# UNITED STATES PATENT AND TRADEMARK OFFICE

09/954,994

<b>Office Action Summary</b>	Application No. 09/954,994	Applicant(s) ESCHE ET AL	
	Examiner Melody M. Burch	Art Unit 3683

## **DETAILED ACTION**

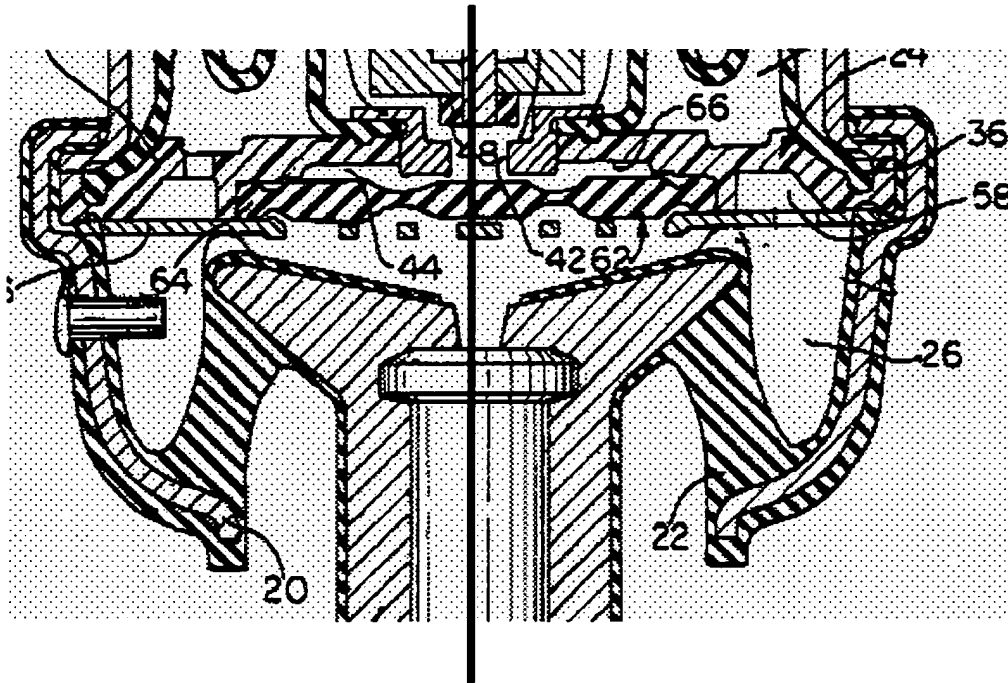
With regards to claim 2 Applicant argues that the means for controlling the preload 22 is not independent of the rod 18. Examiner disagrees. As broadly claimed, elements 18 and 22 are independent by the mere fact that they are two distinct elements. The fact that element 22 can move without causing movement of element 18

in the arrangement set forth in JP'725 also suggests that the two elements are independent.
